Date 30 May 2018
To Hearing Commissioners
From Warwick Goldsmith on behalf of the Requestor, Northlake Investments Limited
Subject Plan Change 53 – Additional Information

**NORTHLAKE INVESTMENTS LIMITED
MEMO:
RESPONSE TO QLDC S42A REPORT ON PC53**

PROJECT: Northlake
PRINCIPAL: Northlake Investments Limited
OUR REF: W4481-7
DATE: May 2018

NORTHLAKE DEVELOPMENT STAGES 1-14

Proposed Water Supply Layout

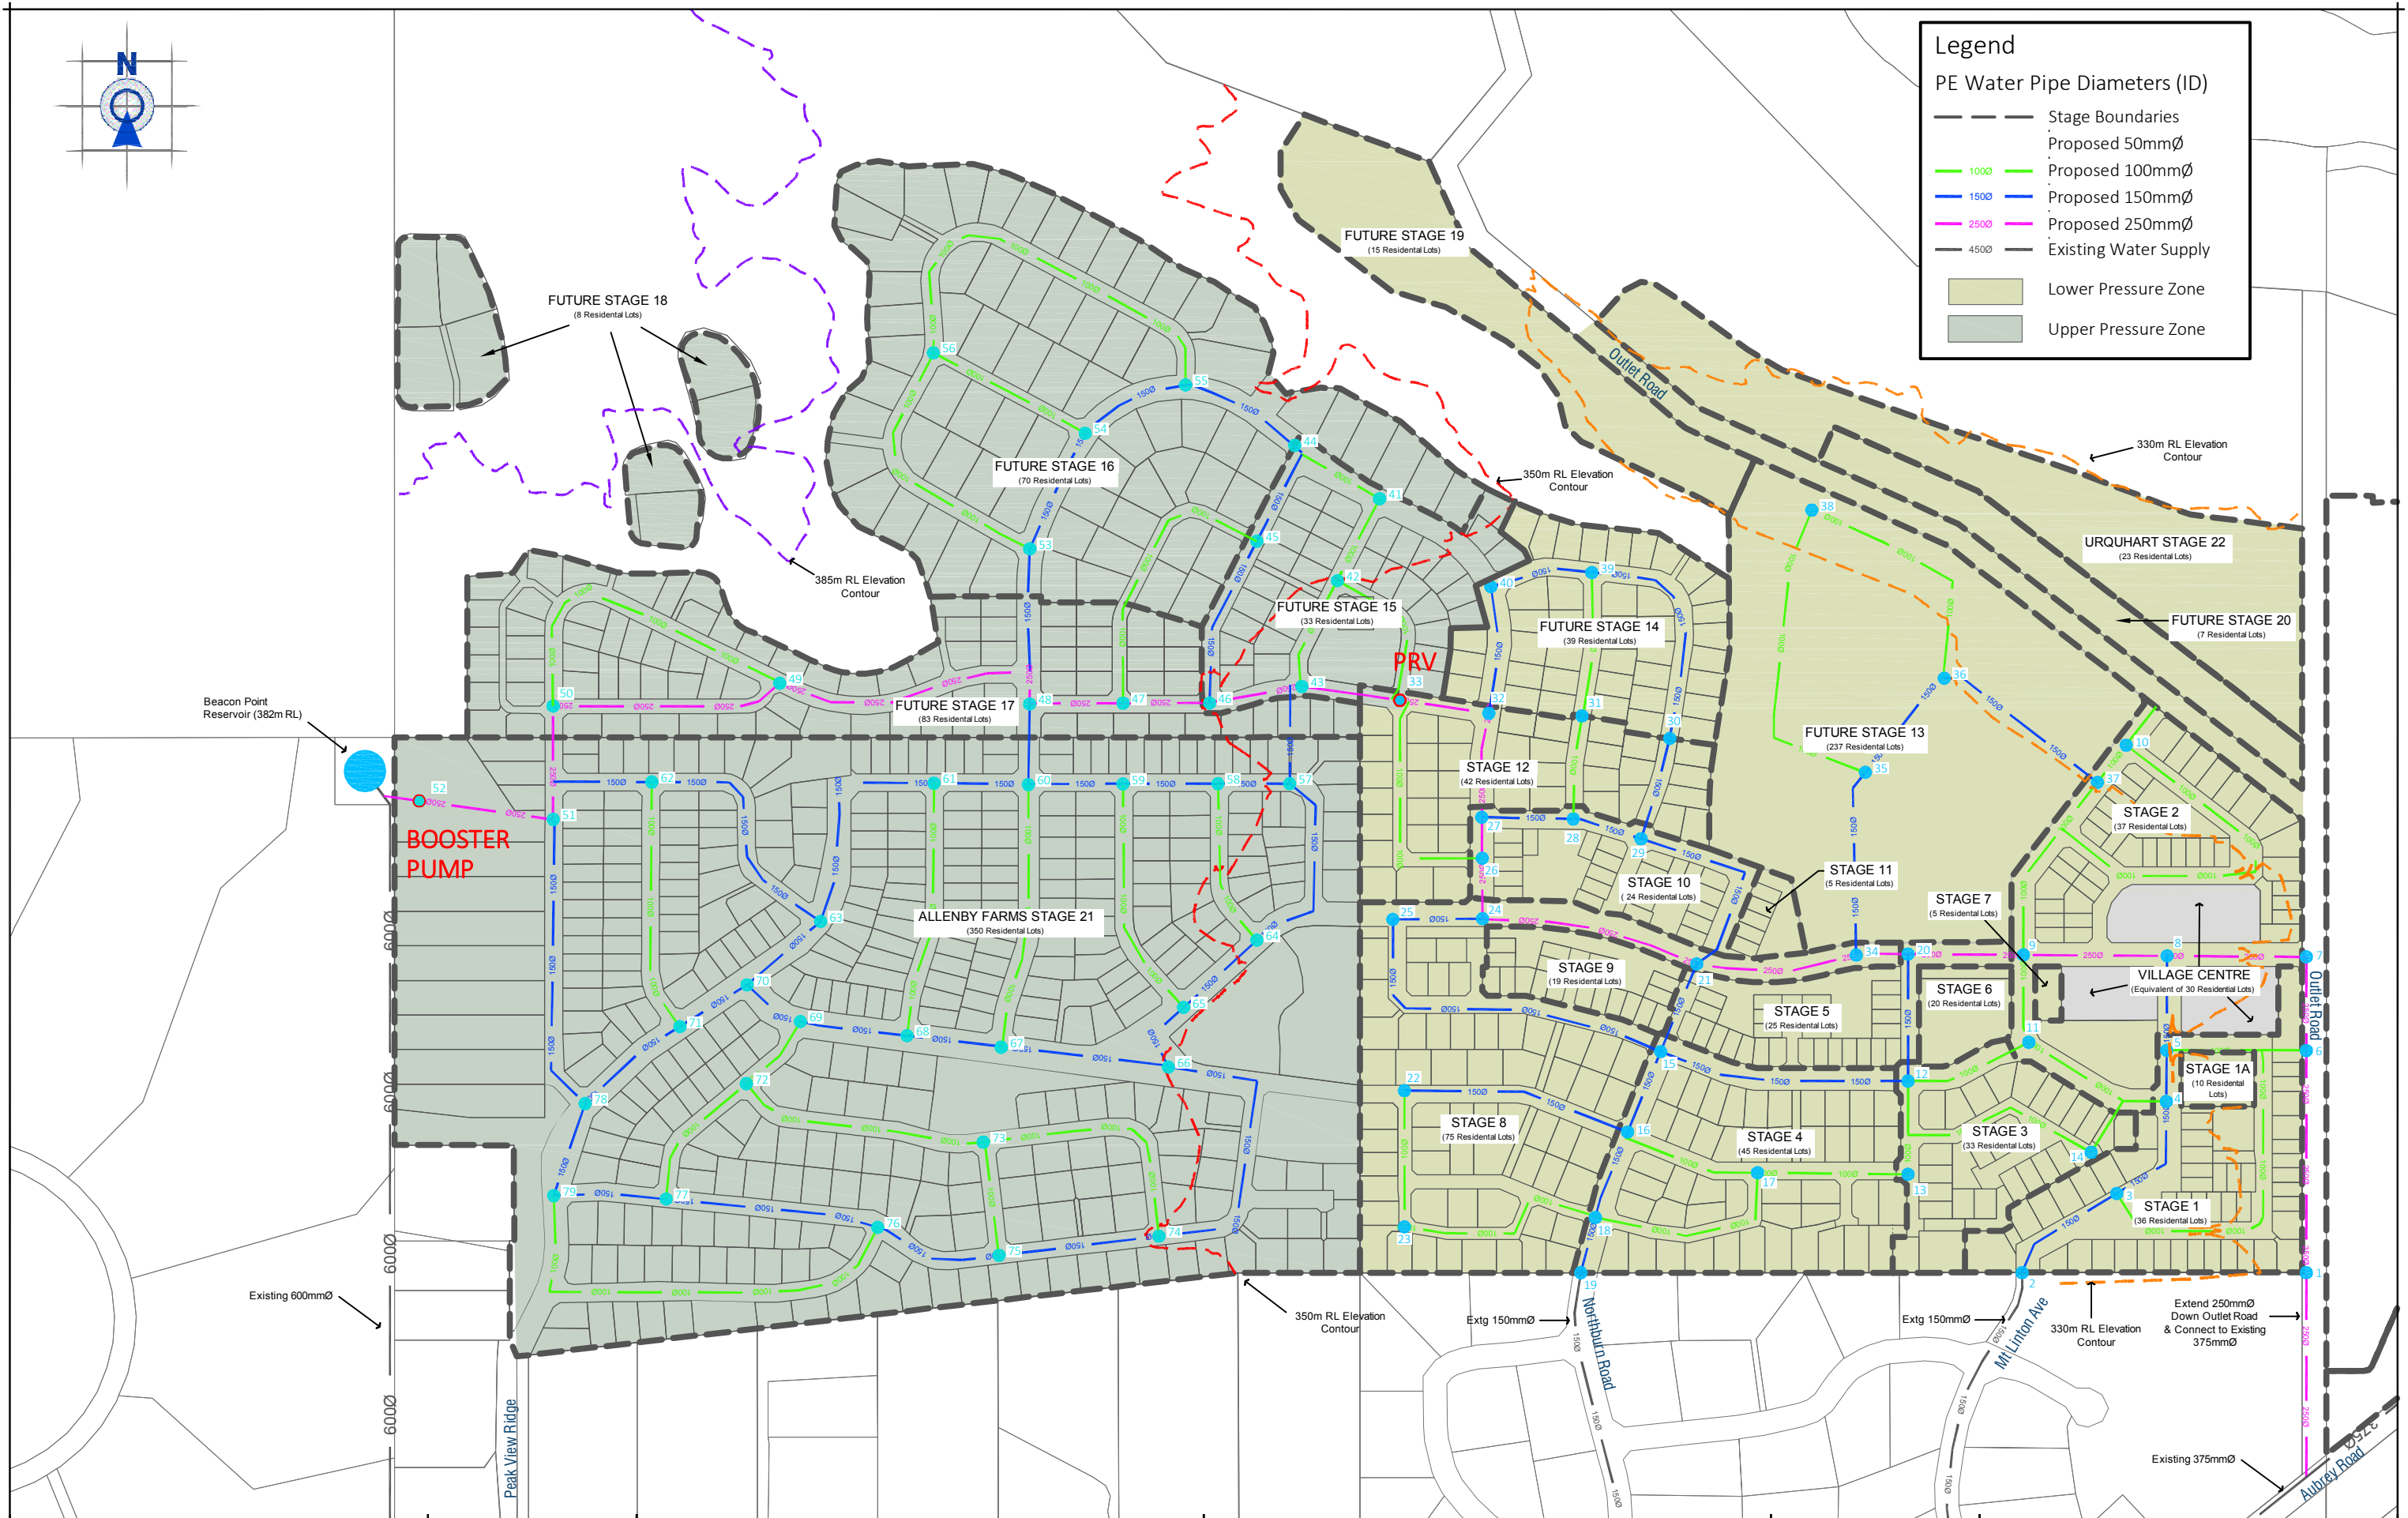
It is also noted that a small area of Stage 14 is above the 350m contour. Consideration should be given to any proposed earthworks and to the proposed zone boundary between the Upper and Lower pressure zones to ensure these sites have sufficient pressures.

In terms of the wider water supply scheme proposed on drawing W4481-7 076 Sheet No. 600 Revision No. 3, it is recommended the pump station is dedicated to supplying only the Upper Pressure Zone. Options for the supply to the Upper Pressure Zone are currently being considered by QLDC and may include a high level reservoir rather than pumping direct online.

The proposed 250mm watermain should remain a gravity watermain through the Upper Pressure Zone to the Lower Pressure Zone. This limits the size of the pump station and ongoing energy costs of pumping excess water only for it to be pressure reduced into the lower zone. It may also be difficult to control the flow through the proposed pressure reducing valve as the Lower Pressure Zone is just part of the much larger Beacon Point Zone, this would then have implications for the design of the pump station, particularly if pumping is direct online.

The modelling results indicate that stages 1-14 can be supplied through the proposed reticulation layout on drawing W4481-7 076 Sheet No. 600 and meet the desired levels of service indicated by Queenstown Lakes District Council. Provided Queenstown Lakes District Councils are comfortable with the level of service provided to the properties on Glenaray Road, and the small area within Stage 14 above the 350m contour is addressed, the proposed water supply design can be accepted.
